TM-1461
(SSC-N-350)
1100.700

Checking the Numbers for the Labyrinths Shown in the SSC Conceptual Design*

J.D. Cossairt
Fermi National Accelerator Laboratory
P.O. Box 500, Batavia, Illinois 60510

April 1987

Figure 6.6-4. Collider Ring Access Shaft plan view.

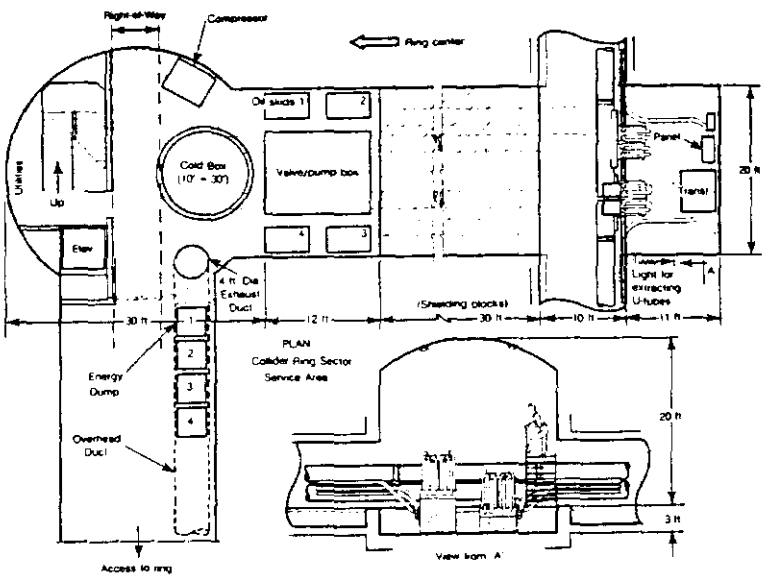
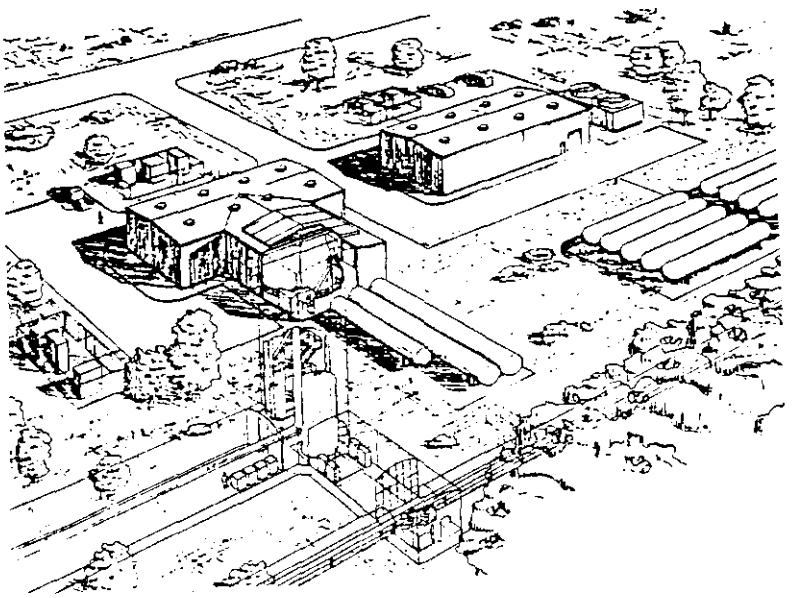
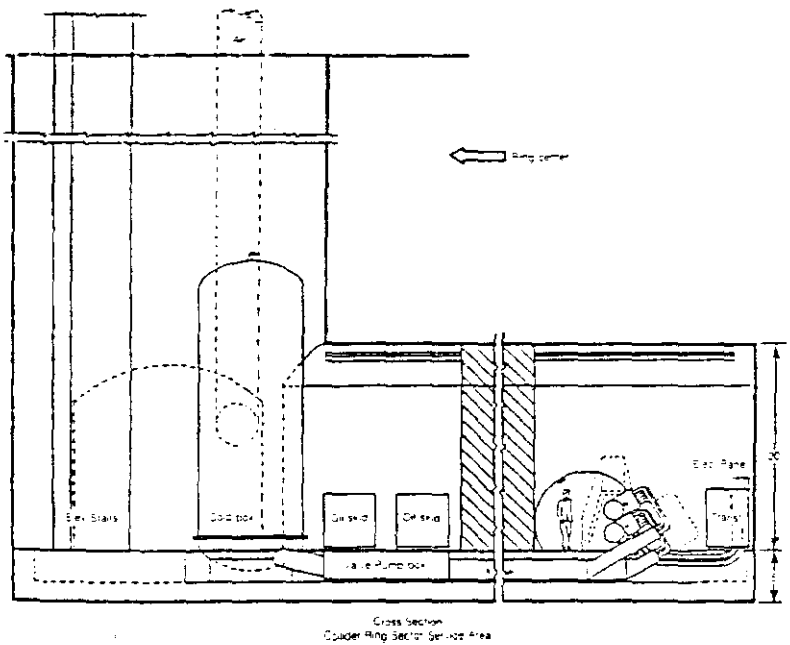
First consider the ring access shaft. I could not find this structure shown in its entirety in the report so I have had to guess what it might look like based upon the written description. The following sketch is an expression of my interpretation. It is to be noted that the length of the second "leg" has not been specified so I will end this discussion by making a suggestion.

First it is necessary to make some estimate of the beam loss conditions and the consequent allowable dose equivalent to a person standing at the top of the access shaft. To do this I have assumed that even under "worst case" scenarios, it is unlikely that more than 10^{12} protons per meter over about 100m of tunnel would likely be lost in any given year. Since these access points are widely distributed in the ring, I believe it would be prudent to limit the dose equivalent in such a place to, say, 10 mrem. From Van Ginneken's recent extensive set of calculations (Va87), figure 66, it is clear that a loss of beam produces a maximum of 2×10^{-6} mrem/proton at the tunnel wall having an inner radius of 1.2 m. As seen above, the accessways being proposed enter the tunnel from the side <u>away</u> from the magnets and hence the "mouth" of the labyrinth views any possible loss point at a distance of about 2.4 m. Also from Van Ginneken's work, for a point loss, only about 10 m of tunnel wall sees more

than half of the maximum dose equivalent. For the assumed loss condition, the dose at the mouth of the labyrinth would simply be given (including a conservative "line source" geometry scaling factor) by:

$$(1.2/2.4) \times (2 \times 10^{-6} \text{ mrem/proton}) \times (10^{12} \text{proton/m}) \times 10 \text{ m} = 10^{7} \text{ mrem.}$$

Thus the desired attenuation factor is $10/(1 \times 10^{7}) = 1 \times 10^{-6}$.

The **first leg** has a cross sectional area of about 5.4×5.4 m^2. Its length, according to my interpretation of the figures, is 17.3 m so that it is 3.2 "units" long. Consider the source to be a "line source", Figure 6 of (Go71) gives an attenuation factor of **0.25** for this leg.

Sections after the innermost were found by Gollon and Awschalom to be similarly effective for rectilinear labyrinths. Since the length of the second is presently unspecified, consider the **third section**. This leg, the vertical shaft, has a cross sectional area of 65 m^2 if one ignores any concrete structures which might be installed (likely to be thin and of limited shielding effectiveness). This means that a "unit" = 8 m. The length of this section, taking the shield over the ring to be the minimal 7 m, is only about 1.2 "units". Still, going around corners always helps and this leg, by the figure from (Go71) attenuates by a factor of **0.06**.

The **second leg** must provide the remaining attenaution factor of **6.6×10^{-5}**. From the figure, this will occur after 10 "units", or **54 m**. These passageways can be made considerably shorter by making them smaller in cross section according to the scaling rules of Gollon.

Figure 6.7-1. Plan View of Type A Interaction Region showing collision hall, access way, shield doors, assembly area and Staging Building.

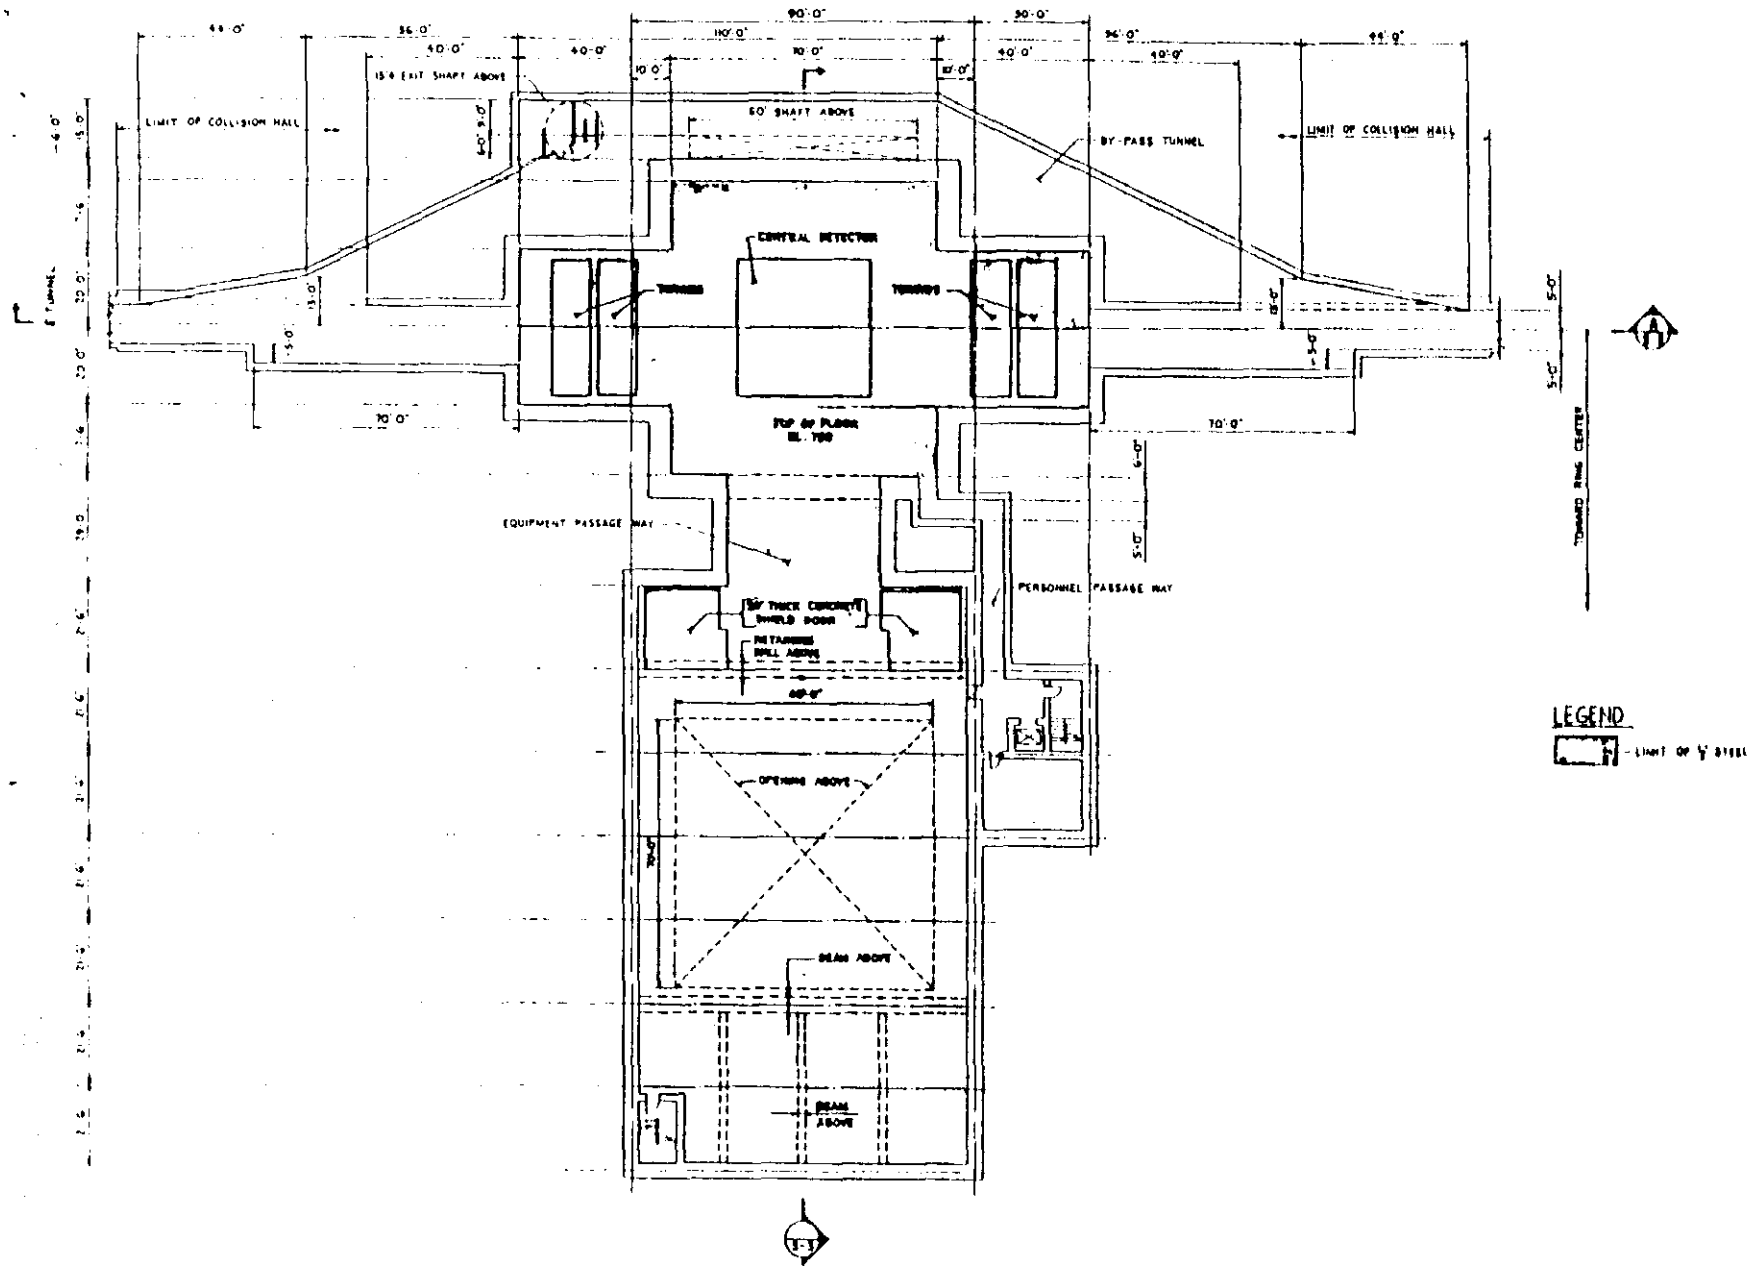
For a "Type A" Interaction Regions (both types being nearly the same for purposes of this discussion) the same procedure may be used. It should be noted that the "mouth" is 37.5' (11.4 m) from the nearest point to the beamline and 48' (14.6 m) from the intended vertex of the collisions. Having no better information, I have estimated that the cross-sectional dimensions of these passageways (which appear to be designed purely for people) to be 5' X 8' which implies a cross sectional area of 40 ft^2. Thus $(A)^{1/2} = 6.3$ ft (1.9 m). Thus the **first leg** is about 1.4 "units" long. From Fig. 6 of Gollon's work, it is conservative to take the attenuation factor of this section to be **0.45**. Continuing with the **second leg**, it is about 17 ft (5.2 m) long and hence approximately 2.7 "units". Thus the figure gives an approximate attenuation factor of **8×10^{-3}** for the second leg. Going now to the **third leg** we find it to be 42 ft (12.8 m) and hence 6.7 "units". The

resulting attenuation factor may be read off as **4×10^{-4}**. Thus the total attenuation for the three-legged labyrinth is **1.4×10^{-6}**.

For this passageway there are two possible types of beam loss to consider. The first is accidental loss upon the beam pipe, a "fixed target" loss. To get an estimate of the source term again consult (Va87). In Figure 70 at a radius of 1.2 m a result of 2×10^{-7} mrem/proton is seen to be a maximum for a loss on a **bare beam pipe** of 20 TeV protons. If one supposes the collision hall to be empty, the loss of 1.3×10^{14} protons directly opposite the labyrinth would, invoking a 1/r dependence, produce a dose equivalent of

$$(1.2/11.4) \times (2 \times 10^{-7}) \times (1.3 \times 10^{14}) = 2.7 \times 10^{6} \text{ mrem}$$

at the mouth of the labyrinth. Multiplying by the attenuation factor determined above would result in a dose equivalent of **3.8 mrem.** It is clearly unlikely that the interaction regions would ever be truly empty, or just contain a bare beam pipe. However, it is more likely that massive components would be in place which would reduce this dose by self-shielding. At any rate, such a catastrophic beam loss is unlikely to occurr even as frequently as annually. This dose equivalent is therefore acceptable for such a controlled laboratory area.

The other type of loss is the steady loss due to the inelastic collisions of the 20 TeV protons. From Figure 144 of the work of Van Ginneken cited above, one finds a dose of 5×10^{-9} mrem/inelastic collision at a radius of 10 m from the vertex. This estimate is <u>highly</u> conservative due to the forward propagation of the particles from these collisions. Nevertheless, allowing for vertex to be in the <u>wrong</u> location (a highly surprising event to the accelerator physicists!) this is a somewhat useful <u>maximum</u> value. If we have, at $\mathcal{L} = 10^{33}$, 9×10^{7}collisions s^{-1} or 3×10^{11} h^{-1}, one would have a maximum dose rate at 10 meters of 1500 mrem h^{-1}. Multiplying by the attenuation calculated above results in a dose equivalent rate of **2.1 μrem h^{-1}** at the worst point. This is an entirely acceptable value.

Thus it appears that the design of the access penetrations is appropriate
